Office Action Summary

10/561,641

HOFFMANN, STEFAN

DETAILED ACTION

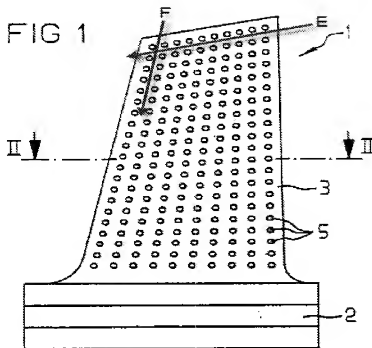
9. As to claims 11 and 19, Birkner discloses a gas turbine (col. 1, line 12, "The invention relates to a gas-turbine blade"), comprising: a compressor section (inherent); a turbine section (inherent); and a combustion chamber (inherent) comprising and a plurality of blades 1 (fig. 1) where each blade comprises: a root portion 2 (fig. 1), an airfoil portion 3 (fig. 1), an outer wall exposed to a hot gas 9 (fig. 5), a first cavity A (fig. 5 above) partly defined by the outer wall and for a first medium [intended use], a plurality

of through-openings B (fig. 5 above) are arranged in the outer wall and where the through-openings open into the first cavity on a first side and into the hot-gas space C (fig. 5 above) on a second side, and a second cavity D (fig. 5 above) for admixing a second medium [intended use], the second cavity being fluidically connected to the through-openings, wherein the second cavity is formed by supply passages F (fig. 1 above) are provided in the outer wall and are connected via transverse passages E (fig. 1 above) to the through-openings designed as through-bores, so that the two media cannot be mixed until inside the through-bores [desired result].

10. As to claim 12, Birkner discloses the outer wall has a multiplicity of through-bores, a multiplicity of supply passages B (fig. 5 above) running between the bores, and a multiplicity of further transverse passages E (fig. 1 above) linking the supply passages with the through-bores.

11. As to claims 13 and 14, Birkner discloses the outer wall has at least two layers (fig. 5) which can be connected to one another (fig. 5, the two layers can be connected to one another), wherein the passages (fig. 5 above) are incorporated between two layers in a layer surface.
